DATE October 4, 2017

PROJECT No. 1780495

**DETAILED DESIGN CHANGE TO CONTAINMENT CELL LINER ANCHOR TRENCH – SATELLITE BAY
PANARCTIC F-68 REMEDIATION PROJECT**

PROJECT
SATELLITE F-68 NWT
ARCTIC CONTAMINATED SOIL AND WASTE CONTAINMENT STRUCTURE
SATELLITE BAY, PRINCE PATRICK ISLAND, NWT

TITLE
TYPICAL SECTION - CONTAINMENT STRUCTURE

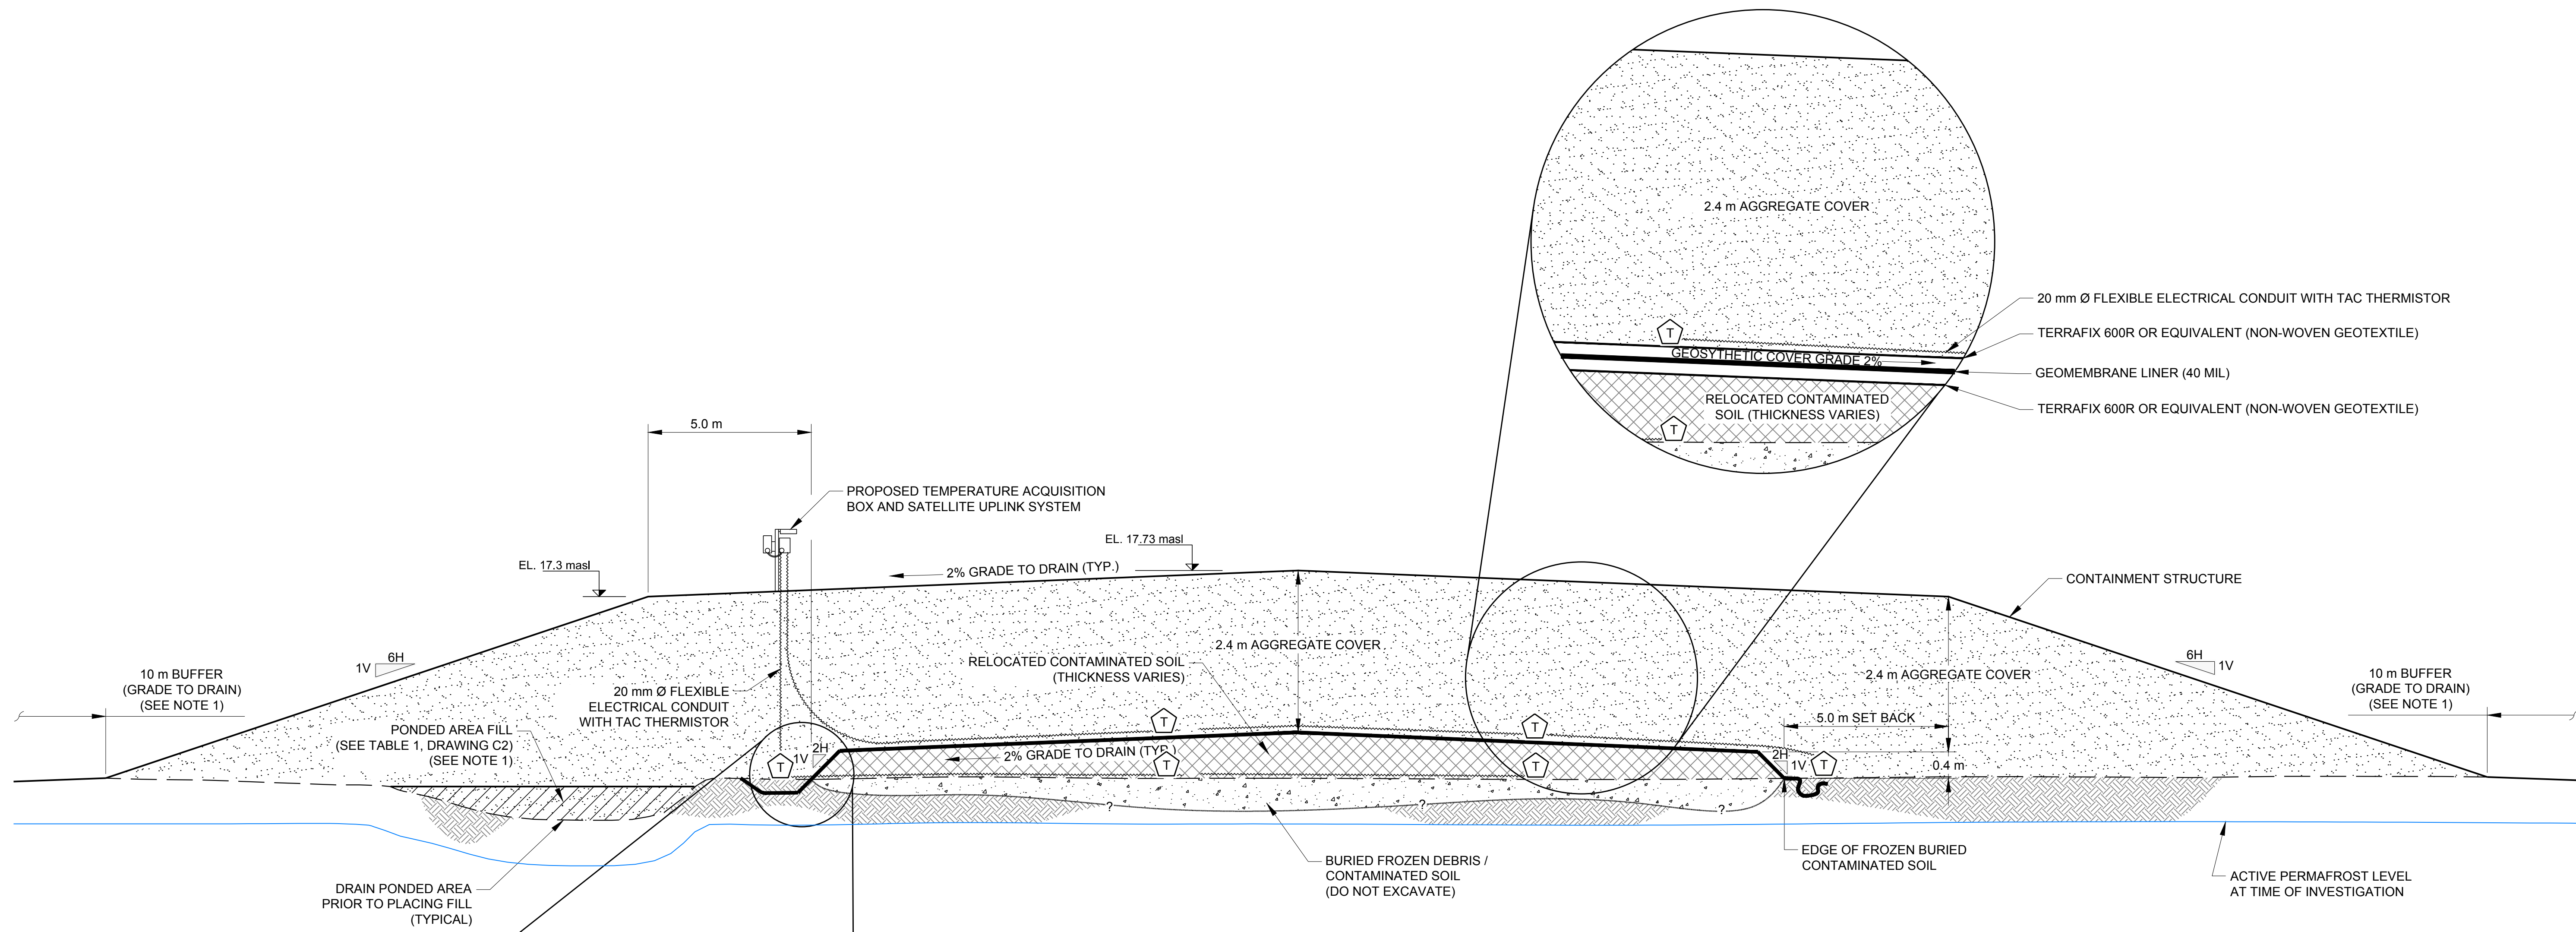
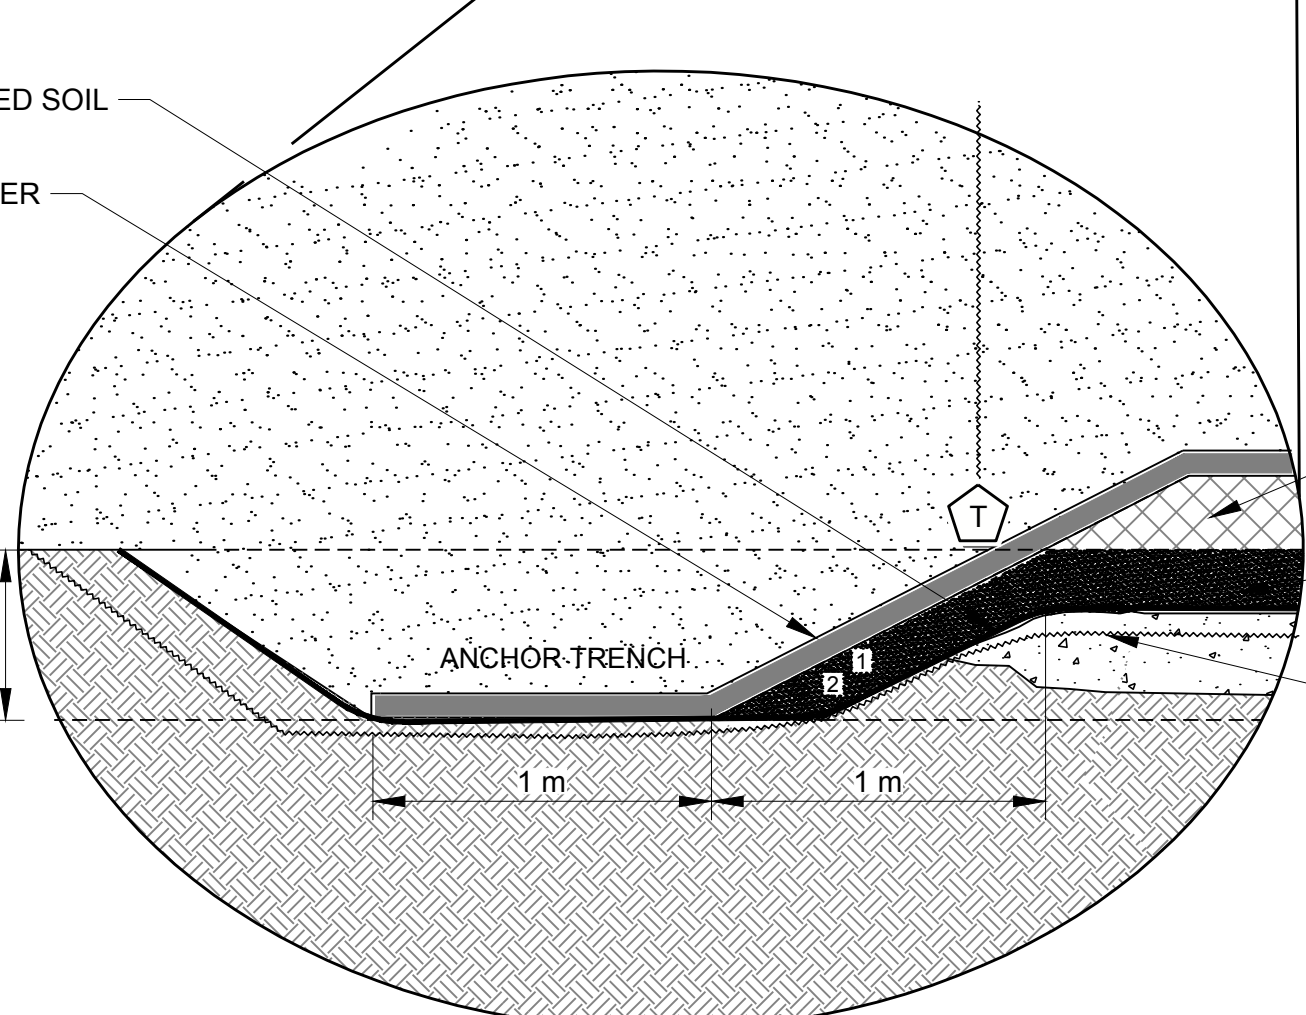
The existing anchor trench layout contained in the detailed design drawings consists of a 0.5 m deep, 0.5 m wide slot, located 1.0 m outside of the toe of the contaminated soil cell limits. It was recommended that, in the alternative, the anchor trench be constructed immediately adjacent to the contaminated soil cell limits and extend as a continuation of the 2:1 slope of the waste fill to a depth of 0.5 m (or to local permafrost), with a base width of 1.0 m. The changed design is on Drawing C5 (appended).

This alternative design can be constructed with the equipment at the Site, consisting of “bobcat” bucket excavators. The resulting design change removes one inflection point of the installation of the liner in the anchor trench, and is therefore an advantage with respect to reduction of stress points on the liner. We consider that this design change is in keeping with the intent of that submitted earlier for approvals in 2016. A copy of this design change should be provided to the Inuvialuit Water Board.

Rev.	YYYY-MM-DD	DESCRIPTION	PREPARED	DESIGN	REVIEW	APPROVED
D	2017-10-02	MODIFIED KEY TRENCH DESIGN	JPR	PJD	TP	
C	2016-11-11	REGULATORY APPROVAL FINAL	JPR	LR	PJD	TP
B	2016-02-03	REGULATORY APPROVAL	CV	LR	PZ	TP
A	2015-10-30	ISSUED FOR 30% DESIGN	CV	LR	LR
